VOLKSWAGEN

2019 ECU update procedure

TN_VAG_02/ 2019

/ ECU Update

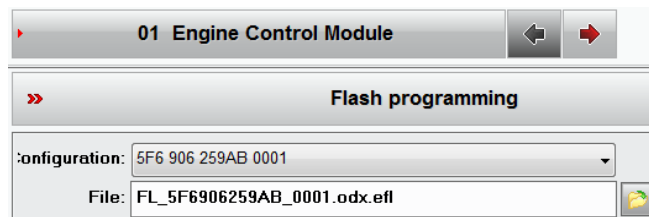
- Unzip the package and install the executable file on the laptop where DiagRA LE is installed.
- Once the installation has been successfully done, the Flash Programming option will be allowed with the 2019 mappings.
- These mappings can be overwritten repeatedly.
- For cars with SEQ gbx, is recommended before starting the flashing process to disconnect the Sybele Gearbox Control Unit placed on the engine bay EM-BOX.
